We thank the editor and both reviewers for their thorough reviews and valuable comments on the manuscript. The responses to reviewer comments (black text) are shown in blue font, added and revised manuscript text is shown in red font, and any original manuscript text is shown in gray font. Figure R1 – R4 are used only in the response document.

## Reply on Review #1

## Reply on Review #2

Figure S3. Climatological March 1<sup>st</sup> SWE (top panels) and April 1<sup>st</sup> SWE (bottom panels) over the WUS (left panels) and Andes (right panels). Black error bars represent the interannual inter-quartile range (IQR).”

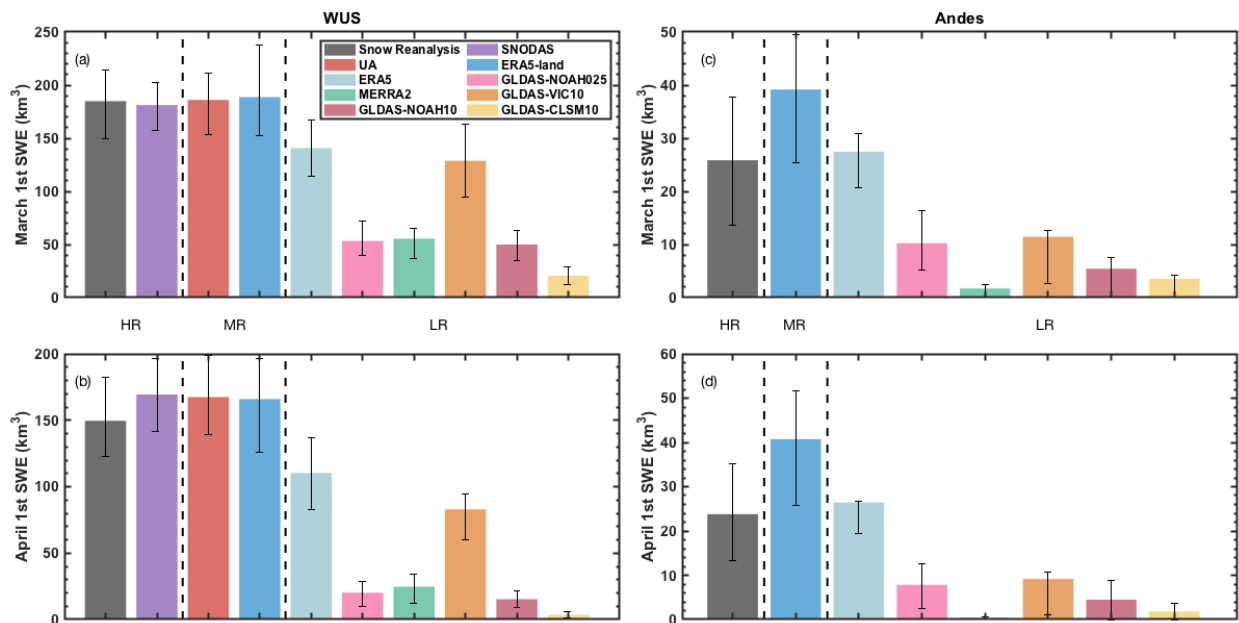
2. The SWE product intercomparison focuses on the “snow accumulation season” (L. 135-145), which is defined as the period before peak SWE (L. 139-140). However the accumulation season is not always well-defined in all years, locations, and spatial scales. For instance, snow may be more intermittent in lower elevations, in drier years, and/or at coarser spatial scales. Notably, the timing of peak SWE varies in these cases (as across the products in Figure 2), which suggests that the uncertainty in snow water storage may be larger at other times in the year (e.g., March 1 in WUS). Hence, I am wondering about whether peak SWE is necessarily the most robust way to characterize uncertainty across snow products? In addition to the analyses presented, it could be helpful to characterize the uncertainty in time (e.g., by dowy) rather than just by a fixed point (e.g., peak SWE).

Thank you for your comment. The rationale for focusing on the pixel-wise accumulation season is that much of the uncertainty comes from the accumulation season and that accumulation errors/differences then propagate to the melt season. It is a valid point that the accumulation season definition may not be optimal for intermittent snow and/or snow in extremely dry years. However, we use the same definition of accumulation season for all years, locations, and spatial scales to maintain consistency over multiple products. It is expected that the key results do not qualitatively change if another proxy date for peak SWE is used (shown below). Hence, we would prefer to keep the current focus on (pixel-wise) peak SWE and the accumulation season in the main manuscript text.

Additional analyses (added in the SI) for March 1<sup>st</sup> and April 1<sup>st</sup> SWE confirm that similar uncertainty conclusions are reached as those when using pixel-wise peak SWE.

Overall, the relative uncertainties of climatological  $SWE_{peak}$  over the WUS (Figure 3k) and Andes (Figure 4i) are consistent with uncertainties of March 1<sup>st</sup> and April 1<sup>st</sup> SWE across different products (Figure S6). In the WUS, HR and MR products generally agree with the WUS-SR, whereas LR products underestimate SWE. The WUS-SR average  $SWE_{peak}$ , March 1<sup>st</sup> and April 1<sup>st</sup> SWE values are 269, 185 and 150  $km^3$ , respectively. In comparison, the average  $SWE_{peak}$ , March 1<sup>st</sup> and April 1<sup>st</sup> SWE values from HR and MR products are 284, 185 and 168  $km^3$ , respectively. Thus, for HR and MR products, March 1<sup>st</sup> SWE has the lowest bias (0%) followed by  $SWE_{peak}$  (overestimated by 6%), and April 1<sup>st</sup> SWE (12%). For LR products, the average  $SWE_{peak}$ , March 1<sup>st</sup> and April 1<sup>st</sup> SWE values are 127, 75 and 43  $km^3$ , respectively. The lowest bias is from  $SWE_{peak}$  (underestimated by 53%), followed by March 1<sup>st</sup> (59%) and April 1<sup>st</sup> SWE (71%).

In the Andes, Andes-SR shows that  $SWE_{peak}$  is 29  $km^3$ , March 1<sup>st</sup> SWE is 26  $km^3$  and April 1<sup>st</sup> SWE is 24  $km^3$ . The average values for MR and LR are 19, 14 and 13  $km^3$ , respectively.  $SWE_{peak}$  has the lowest bias (34%), followed by March 1<sup>st</sup> and April 1<sup>st</sup> SWE with the same level of bias (46%).

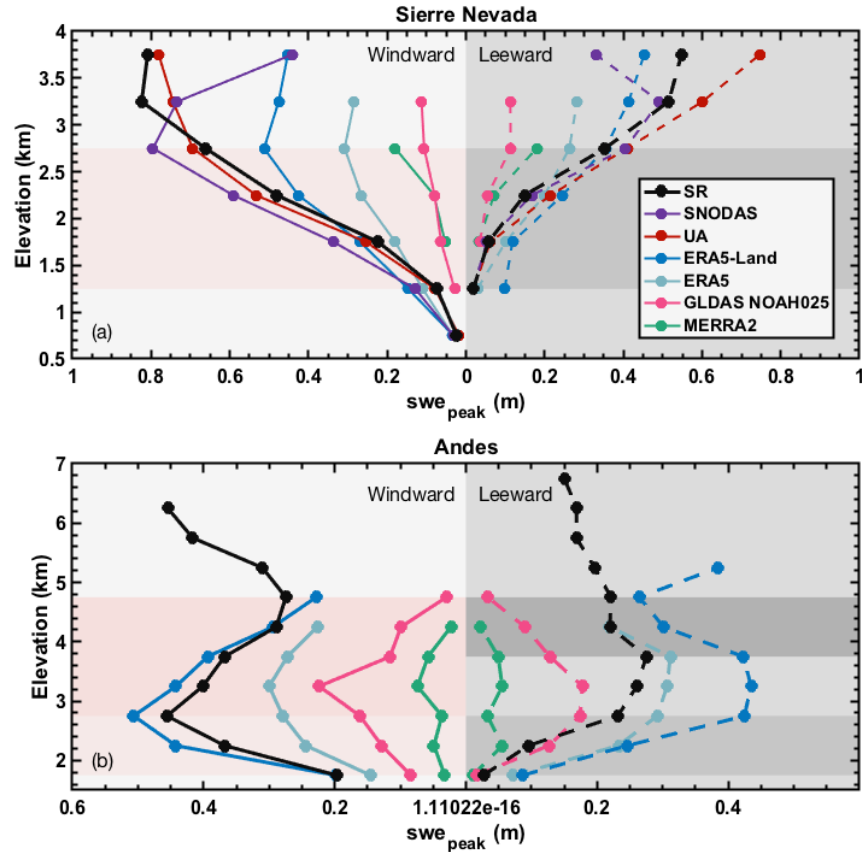
3. Section 4.1 analyses spatial variations in peak SWE across the study regions and with respect to windward/leeward basins. One aspect that would be useful to analyze and compare across products is the lapse rate in peak SWE across the windward/leeward sides. While peak SWE is lower in the LR products and higher in the HR products (Figures 5-6), it must be remembered that the LR products have less variation in elevation than the HR products. As such, I think this should be normalized in order to assess how the elevation gradients in peak SWE compare across products. This would be potentially important to know for certain applications (e.g., downscaling a LR product to higher resolution).

Thank you for your suggestion regarding the lapse rate in peak SWE. Additional analysis and Figure 7 have been added in the main text as shown below:

“The elevational distributions of bin-averaged climatological  $swe_{peak}$  in the Sierra Nevada (Figure 7a) and Andes (Figure 7b) are plotted to compare the elevational gradient of windward and leeward  $swe_{peak}$  from products with different spatial resolutions. The lapse rate in  $swe_{peak}$  was determined by linear regression of  $swe_{peak}$  averaged across elevational bins (Text S5). Lapse rates from GLDAS products at 1.0° are not included because the subdomains analyzed are covered by less than 10 pixels (Figure S7 and S8).

Based on the WUS-SR, climatological  $swe_{peak}$  on the windward side of the Sierra Nevada monotonically increases up to ~3.5 km. Across different products, the uncertainty of  $swe_{peak}$  is smaller at the lower elevation ~ 1-1.5 km, however, the differences in lapse rate project to larger  $swe_{peak}$  uncertainty as elevation increases. The gradients of windward  $swe_{peak}$  (i.e.,  $d(swe_{peak})/dz$ ) from WUS-SR, averaged over HR and MR products, and averaged over LR products are 0.40 m/km, 0.38 m/km, and 0.10 m/km, respectively. On the leeward side of the Sierra Nevada, the  $swe_{peak}$  increases monotonically with elevation from 1 – 3.5 km in the WUS-SR and most of the other products. Similarly, the uncertainty of  $swe_{peak}$  is smaller at low elevation from 1 – 1.5 km and gradually increases with elevation corresponding with the differences in lapse rate across different products. The gradients of leeward  $swe_{peak}$  (i.e.,  $d(swe_{peak})/dz$ ) from WUS-SR, averaged over HR and MR products, and averaged over LR products are 0.22 m/km, 0.23 m/km, and 0.13 m/km, respectively. HR and MR products have qualitatively similar elevational distributions of  $swe_{peak}$  on both the leeward and windward side of the Sierra Nevada for elevations below 3 km, whereas that  $swe_{peak}$  from LR are underestimated with large differences in lapse rates compared to WUS-SR.

On the windward side of the Andes,  $swe_{peak}$  from the Andes-SR increases from 1.5 – 3 km, with decreases between 3 and 5 km. The  $swe_{peak}$  uncertainty is smaller at low elevation bands between 1.5 - 2 km. The uncertainty gets larger as elevation increases from 2 – 3 km corresponding to large differences in positive lapse rates. In contrast, large differences in negative lapse rates above 3 km reduces the uncertainty as elevation increases. The lapse rates of windward  $swe_{peak}$  from the Andes-SR are 0.4 m/km between elevation bands of 1.5 – 3 km and -0.16 m/km between 2.5 – 5 km (Table S1). On the leeward side,  $swe_{peak}$  increases between 1.5 – 4 km and slightly decrease above 4 km in the Andes-SR. Similar to the windward side, differences in positive lapse rate below 3 km project to larger  $swe_{peak}$  uncertainty as elevation increases from 1.5 km, whereas differences in negative lapse reduces uncertainty as elevation increases above 3 km. The lapse rates of windward  $swe_{peak}$  from the Andes-SR are 0.27 m/km between elevations of 1.5 – 3 km, and -0.03 m/km between 3.5 – 5 km.”

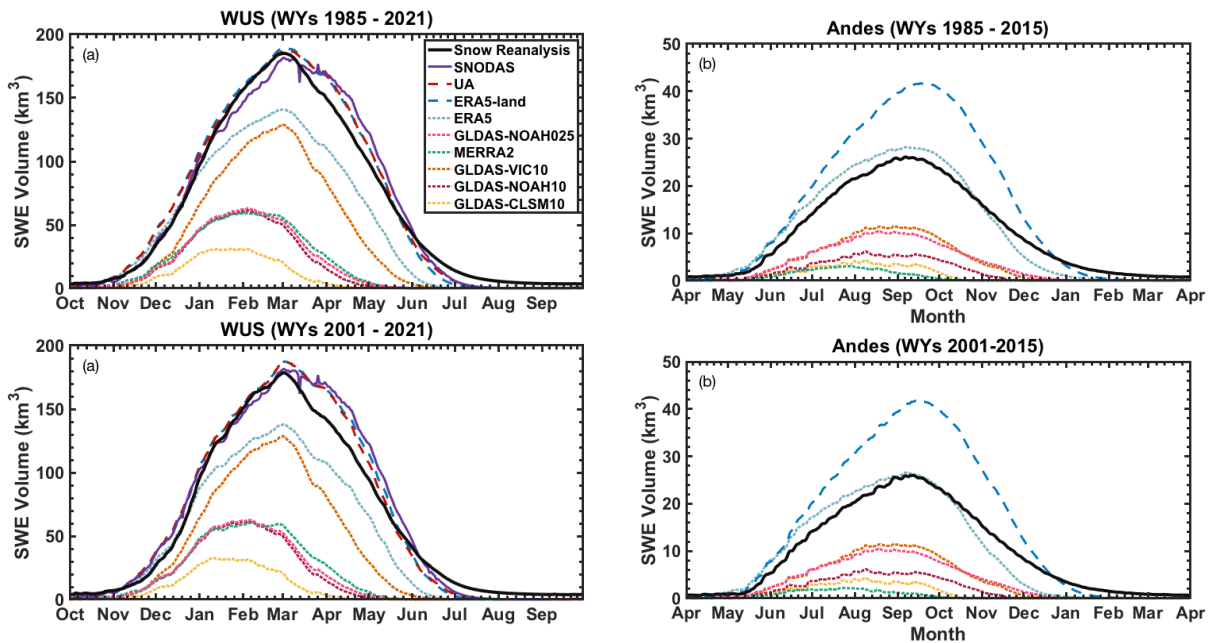
- Line 131-134: I think this climatological analyses could be of interest, and would request their inclusion in the supplement document.

We added climatological analysis from WYs 2004 to 2021 in WUS and from WYs 2001 to 2015 in the Andes in the supplemental information. The additional analysis is shown below:

“In the WUS, GLDAS products are only available over Water Years (WYs) 2001 to 2021, and SNODAS is only available over WYs 2004 to 2021, while all other products span the 37-year record (WYs 1985 to 2021). In the Andes, the GLDAS products are only available over WYs 2001 to 2015, while all other products span the 31-year record (WYs 1985 to 2015).

The climatological SWE over the longer study periods agrees well with climatological SWE over the shorter periods (Figure S1). In WUS, climatological SWE from SNODAS, UA and ERA5-Land are comparable with WUS-SR for either time period used whereas other products underestimate SWE volumes in both cases. In the Andes, over both time periods, ERA5-Land overestimates SWE, ERA5 generates comparable SWE, and the other products underestimate SWE compared to the Andes-SR.

Figure R1. scatter plot of peak SWE from Reanalysis SWE and in situ SWE from SNOTEL and CDEC over the WUS in WY 1993.

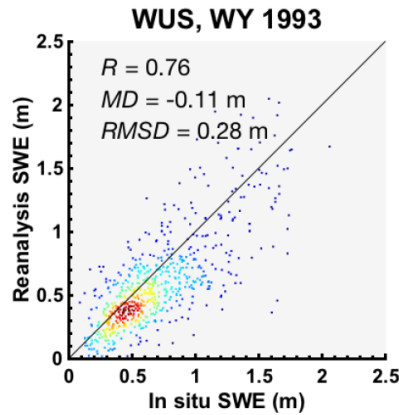
- Figure 7b-c: There appears to be an interesting outlier year where UA and ERA5-Land have much lower peak SWE than WUS-SR. This appears to be a high snow accumulation year. Can you please identify which year this is in the text and provide a brief discussion point about it? These products have greater correspondence to WUS-SR in most other years, so this year may be negatively skewing the error statistics.

The outlier is WY 1993 which is identified as the wettest year in WUS-SR record. It is not clear to us why UA and ERA5-Land disagree with the WUS-SR in this year. A comparison of WUS-SR and in situ peak SWE in WY 1993 shows that WUS-SR agrees with the in situ SWE with a correlation coefficient of 0.76. A negative mean difference suggests that  $SWE_{peak}$  from WUS-SR is slightly lower than that from in situ data. The reanalysis performance for this year is comparable to other years and the overall verification results.

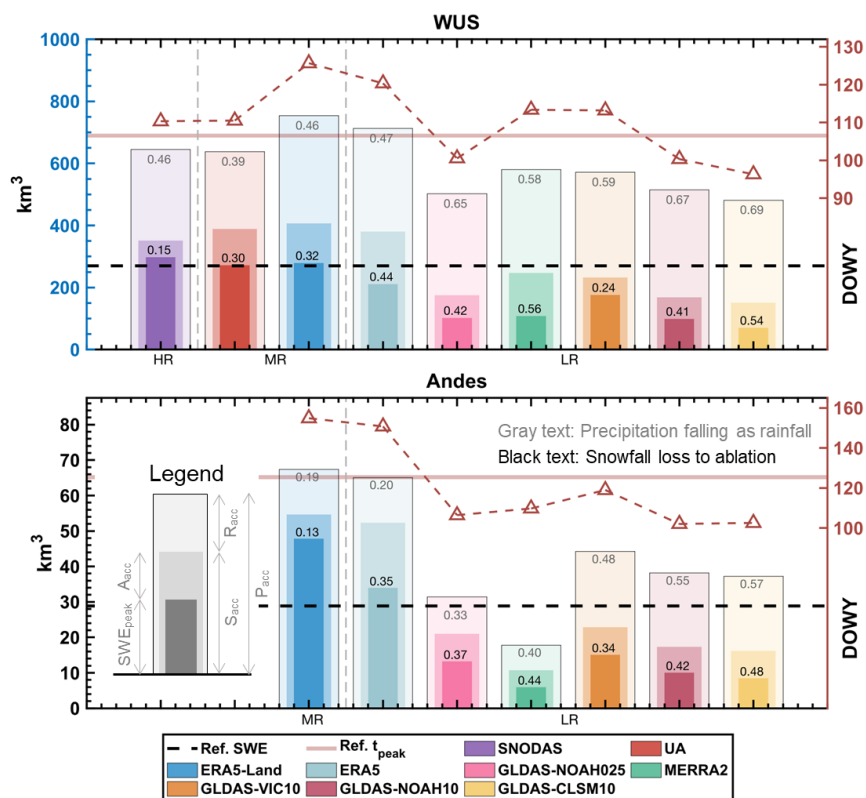
- Figure 10: It would be helpful to include a dashed line for the  $t_{\text{peak}}$  (DOWY) of the reference data.

We have added the  $t_{\text{peak}}$  (DOWY) values of WUS-SR and Andes\_SR as solid red lines in Figure 10 as shown below.

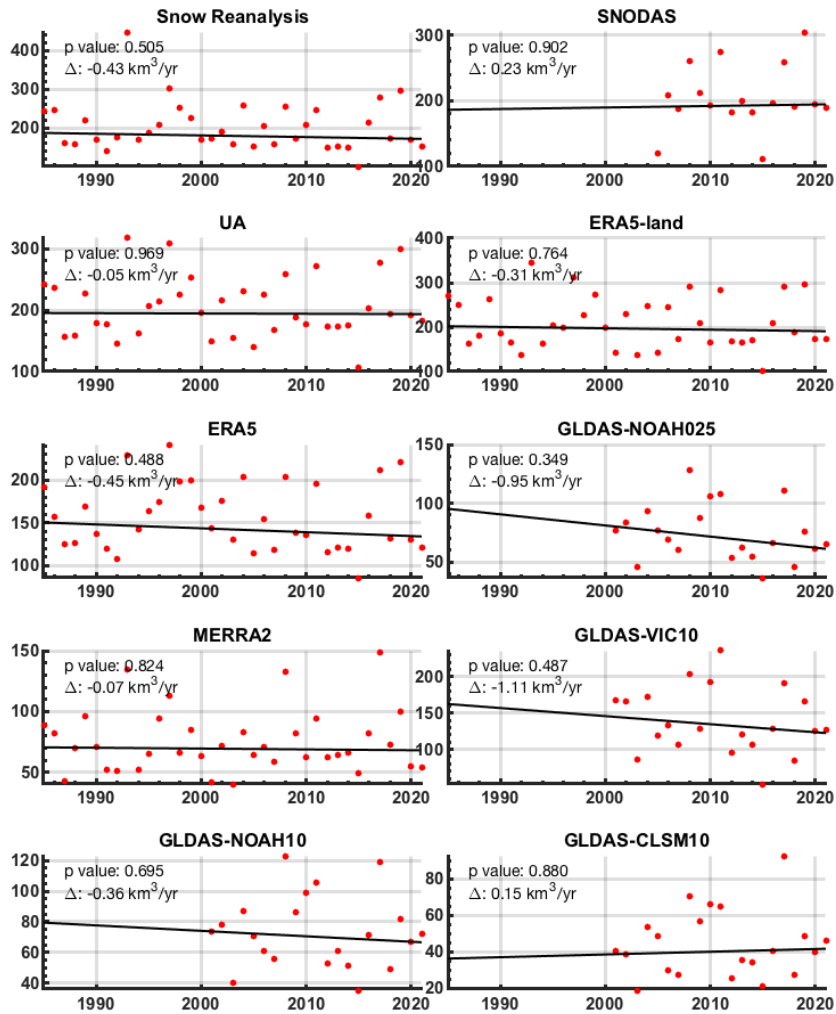
2. Please discuss the implications of snow model uncertainty in coarse scale model (> 10 km) applications on the topic of snow volume sensitivity to warming. For example, Siirla-Woodburn et al. (2021) cited in this paper uses coarse-scale model output and concludes a dire water resource scenario for mid-century. Might results of such studies be different and arguably more accurate if models were run at finer spatial resolution?

Additionally, we computed the snow volume loss trends. However, we found that WUS-aggregated snow trends are not significant (p-value > 0.05) over all the products and that the snow loss rates vary significantly (Figure R3), likely in part due to the relatively short analysis periods.
